DOCKET ITEM #7
Special Use Permit #2011-0063
3310 Holly Street

Application	General Data	
Consideration of a request to construct a single-family dwelling on a substandard lot.	Planning Commission Hearing:	December 6, 2011
	City Council Hearing:	December 17, 2011
Address: 3310 Holly Street	Zone:	R-8 / Single-Family Residential
Applicant: Alabama Ave LC, represented by Steve Kulinski, architect	Small Area Plan:	Potomac West

SUBJECT: SUP REQUEST FOR SINGLE-FAMILY DWELLING ON
SUBSTANDARD LOT AT 3310 HOLLY STREET (DOCKET ITEM #7)

1
A3 **PROPOSED PLAN**
SCALE: 1/16" = 1'-0"

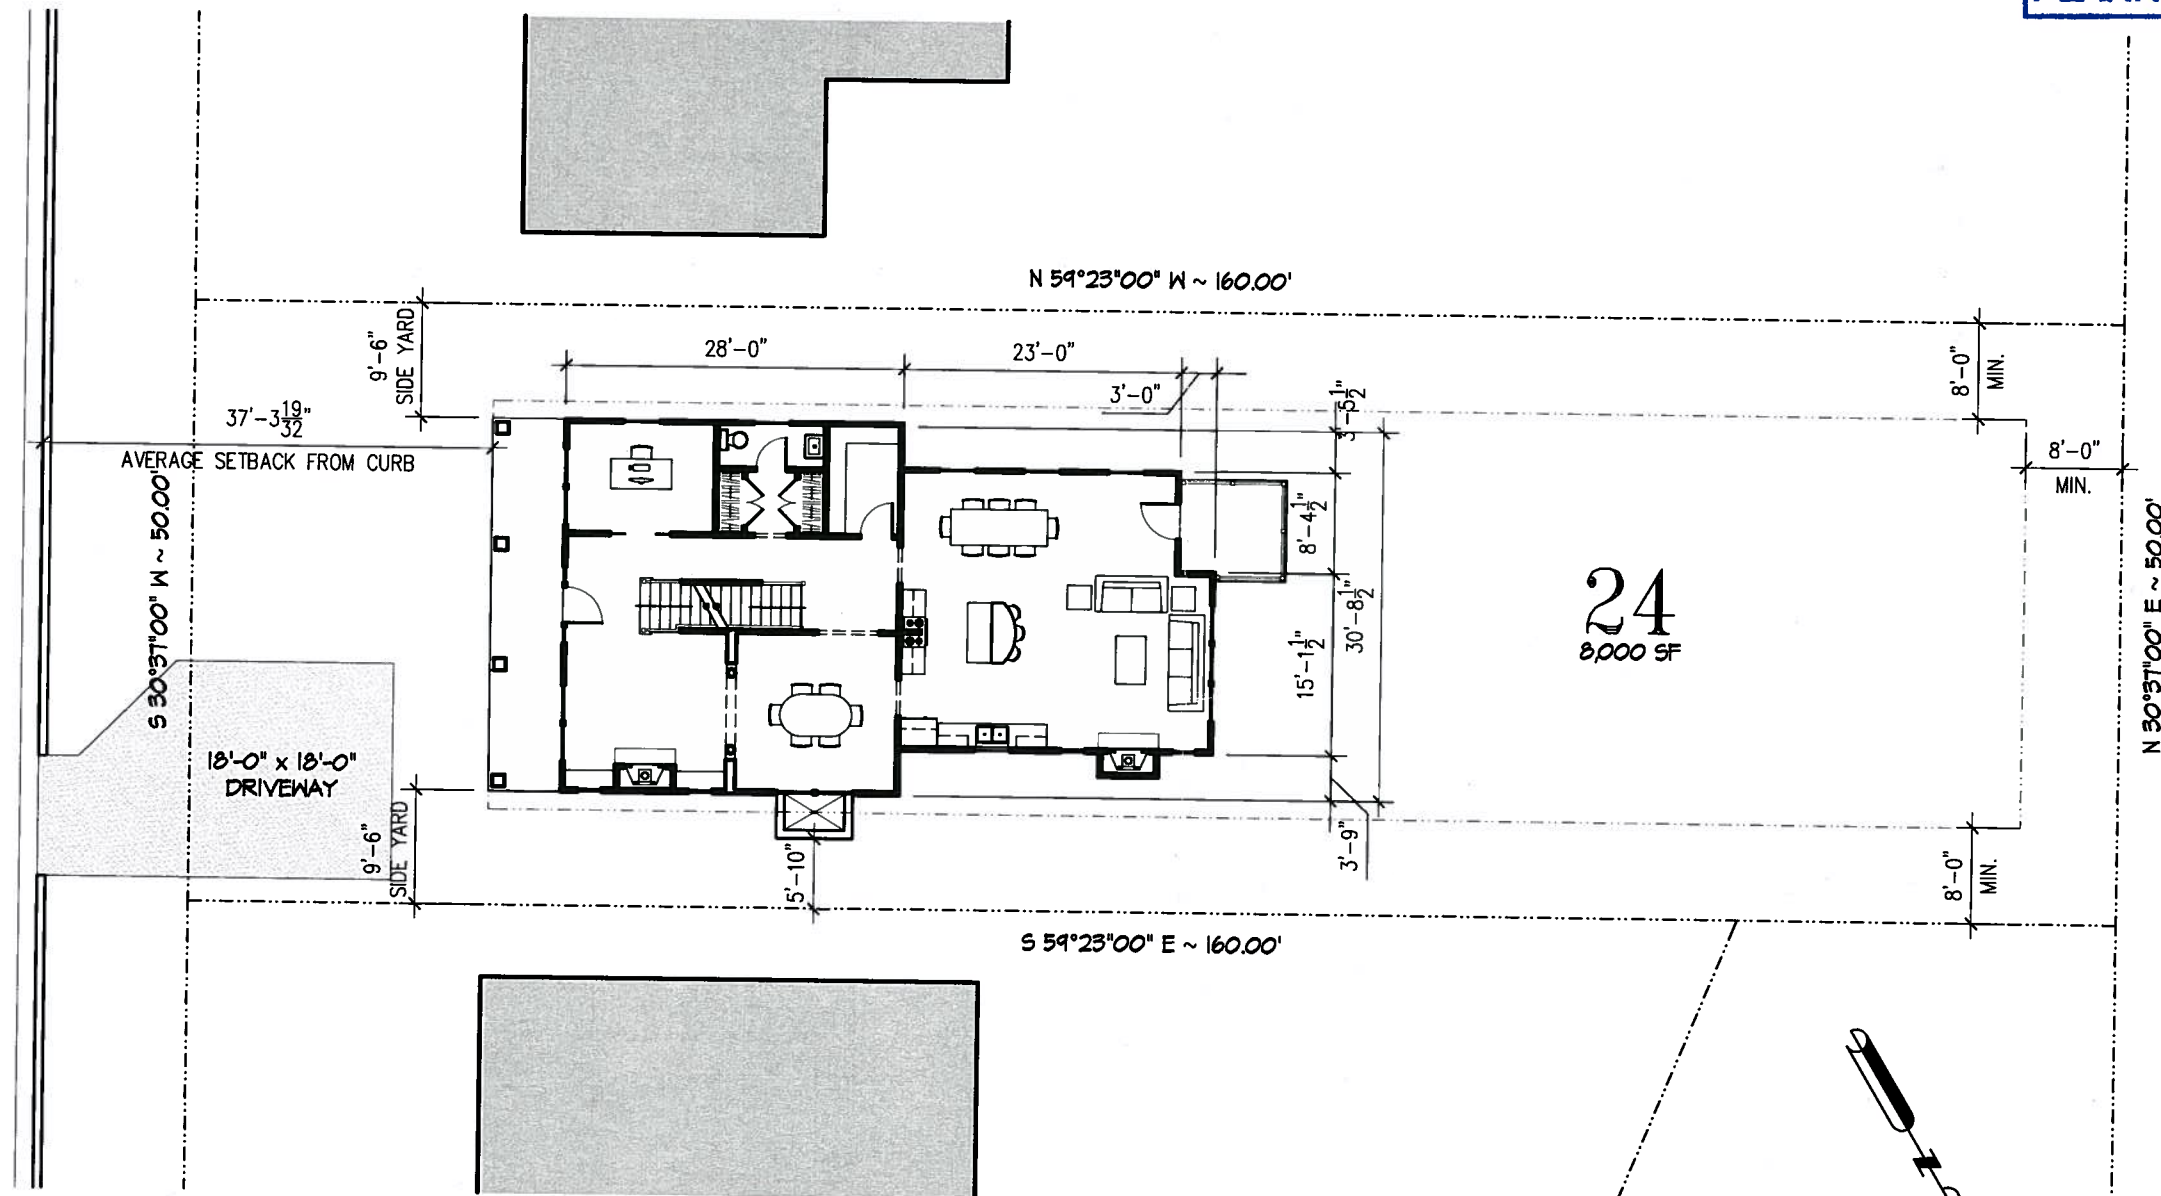
On the other hand, staff does not support the applicant's request for side yard modifications, finding them neither necessary nor desirable in order to develop the lot. Although small side yards, some as small as 4.5 or five feet, are present at several properties in the immediate area, the repetition of reduced-size side yards here is not necessary to develop the lot. The applicant can, despite the significant grade change noted as the justification for the modification, easily narrow the width of the house by 1.25 feet on each side, or 2.5 feet in total, and meet the Zoning Ordinance requirement. Staff also finds that the modifications are not desirable here. The required 10.75-foot side yards will not make the building appear out of place given that a variety of side yard setbacks exist in the neighborhood and that the reduced dwelling width of 28.5 feet is not significantly narrower than other dwellings on the block. Staff therefore recommends in Condition #1 that the applicant narrow the dwelling in order to meet required side yard setbacks.

Staff also finds the proposed double-wide driveway to be objectionable and is recommending in Condition #2 that the applicant provide two parking spaces in a driveway designed in a tandem parking arrangement that is no wider than the width of one vehicle. The proposed double-wide driveway design occupies too much of the front yard and interrupts the neighborhood pattern of either single-wide driveways or no driveways at all. Condition #2 requires the driveway to be constructed using a permeable paving system, which is a standard requirement for new single-family dwellings requiring SUPs.

Finally, staff is concerned about an especially large oak tree on the southern side of the applicant's property which the applicant claims cannot be saved. Staff is recommending in Condition #3 that the applicant plant a new, replacement tree on the lot, which requirement is in addition to the 25% tree crown coverage requirement from the Zoning Ordinance.

1. The design and placement of the dwelling shall be substantially consistent with the illustrations dated November 17, 2011 to the satisfaction of the Director of Planning & Zoning except that the applicant shall meet the minimum side yard requirement on both sides of the proposed dwelling. (P&Z)

2. The driveway shall be constructed to accommodate two parking spaces in a tandem arrangement consistent with Zoning Ordinance requirements, shall be limited in its width to not more than 9.5 feet wide, and shall use a permeable paving system to the satisfaction of the Director of Planning & Zoning. (P&Z)

3. The applicant shall install a new tree on the southern side of the property or other appropriate location, to the satisfaction of the Director of Planning & Zoning, to replace the existing oak tree that will be removed. The subject tree shall be required in addition to the tree crown coverage requirement found in the Zoning Ordinance. (P&Z)

1 PROPOSED REAR ELEVATION
A6 SCALE: 1/4" = 1'-0"

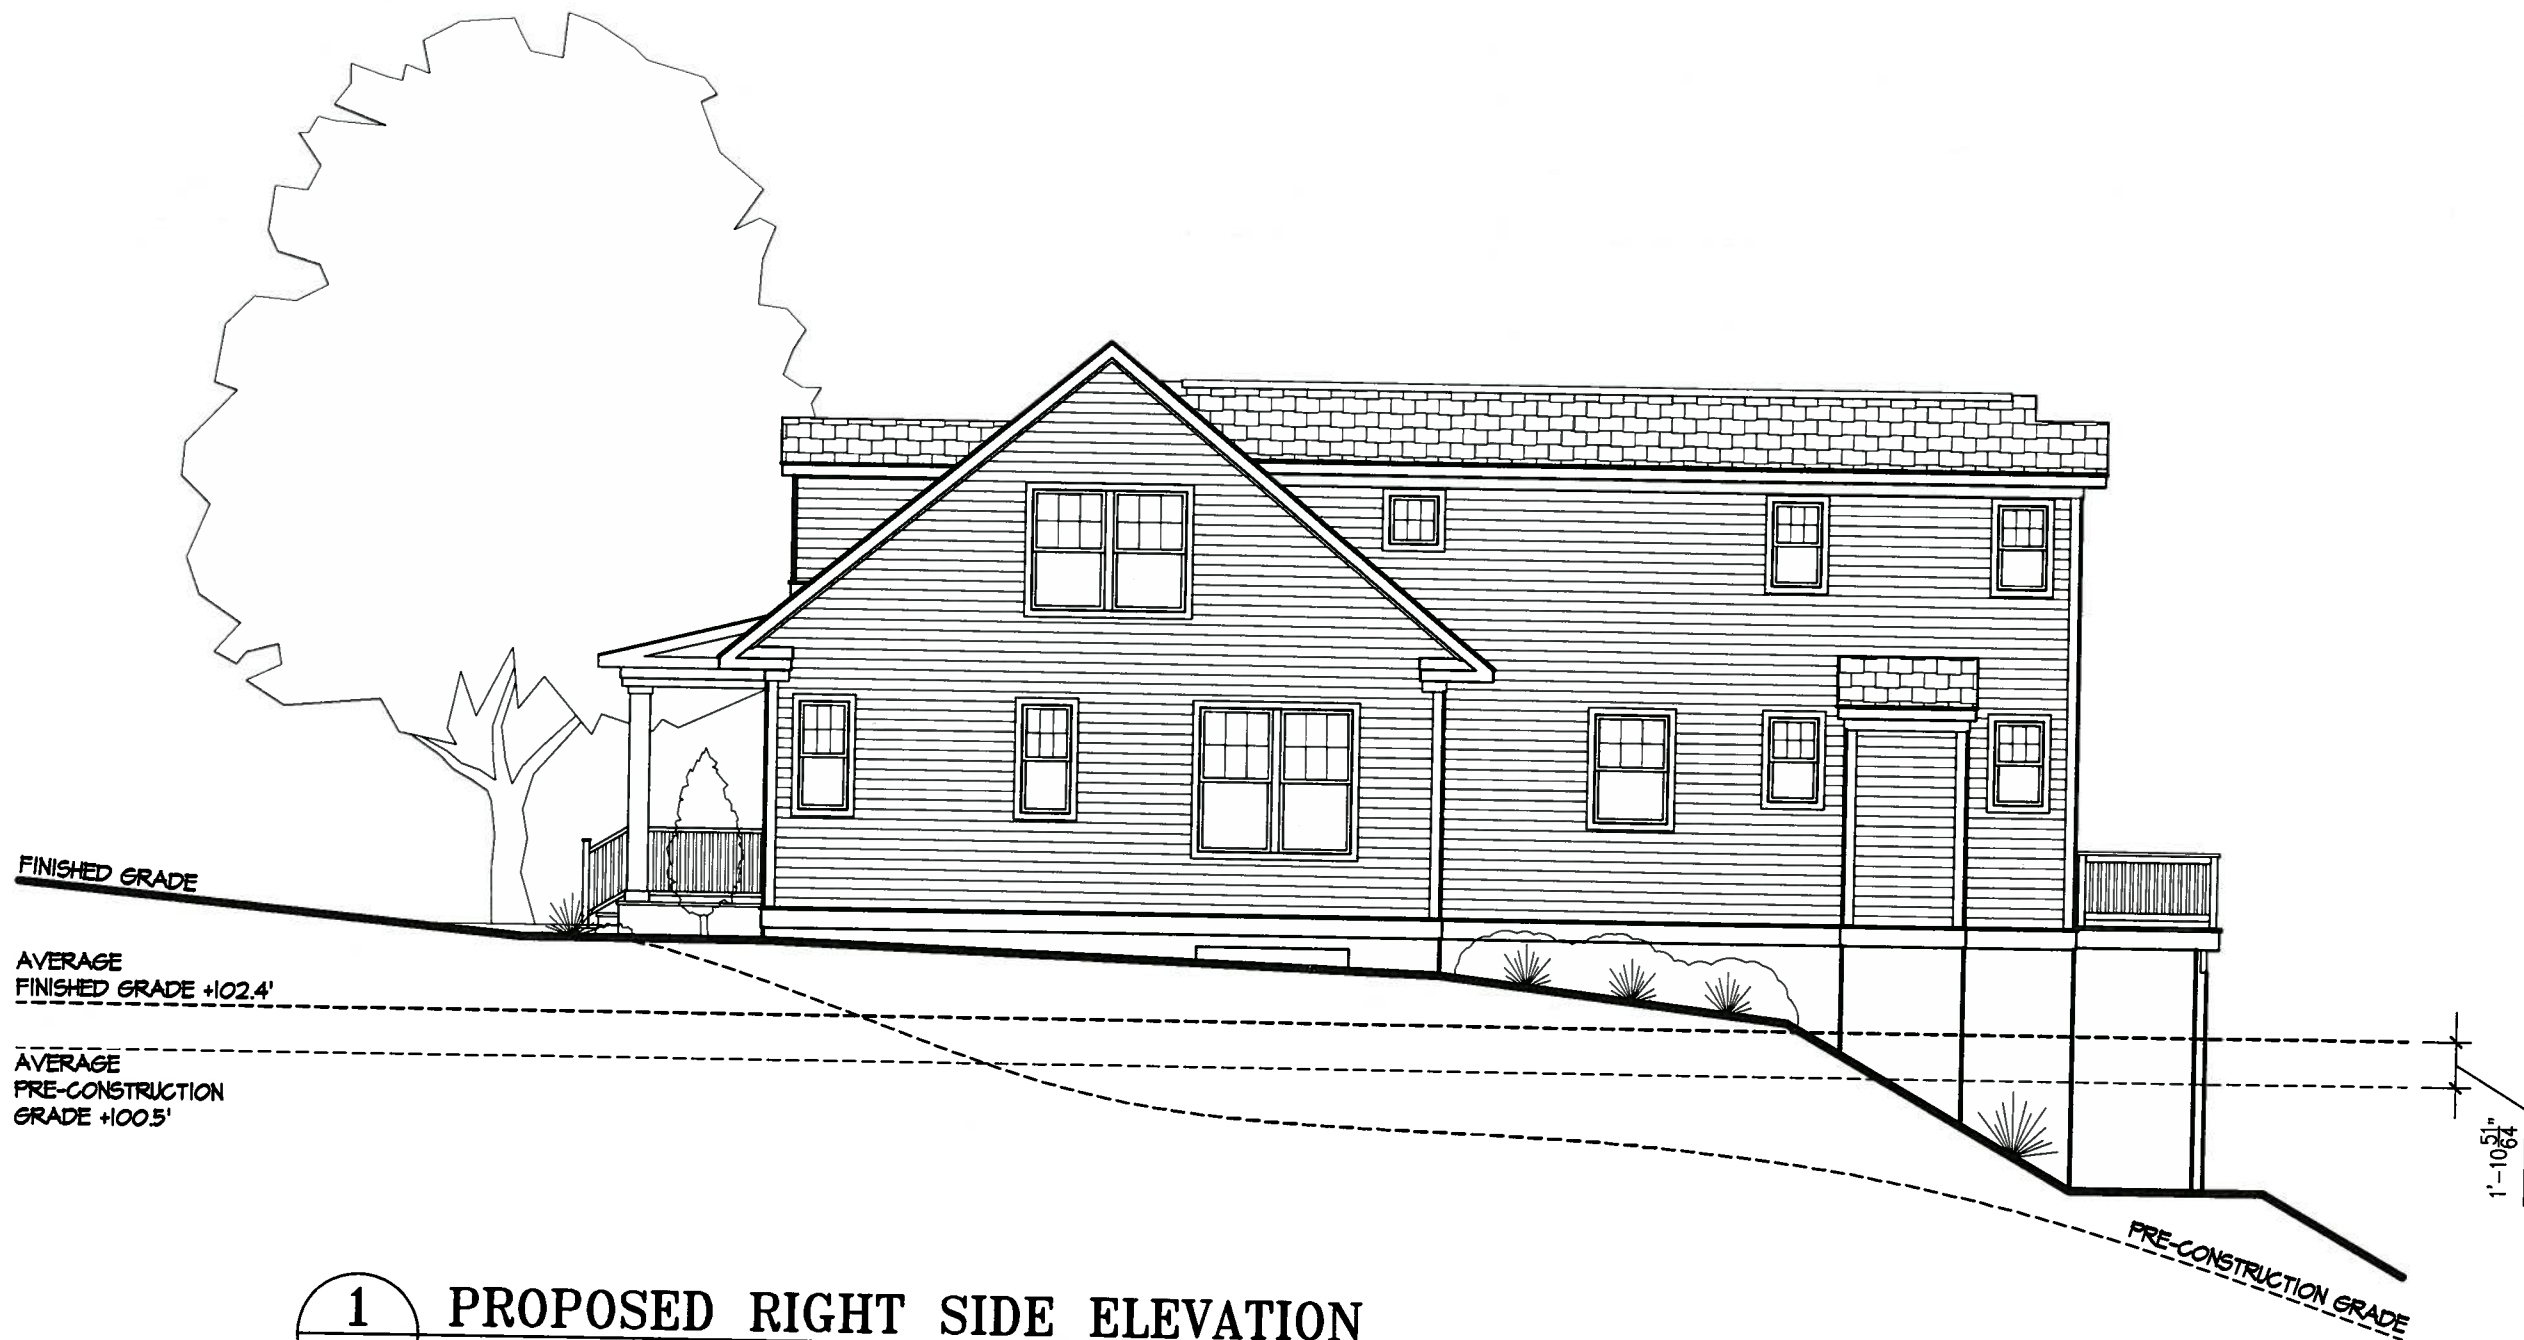
There is a modification for threshold height, which staff supports. The proposed threshold height is 2.75 feet as measured to existing grade; the infill rules require it to be only 2.4 feet to existing grade. The difference is slight, approximately four inches, and the difference will not be perceptible from the street, especially because the grading necessary to build on the lot will reduce the apparent threshold height after construction.
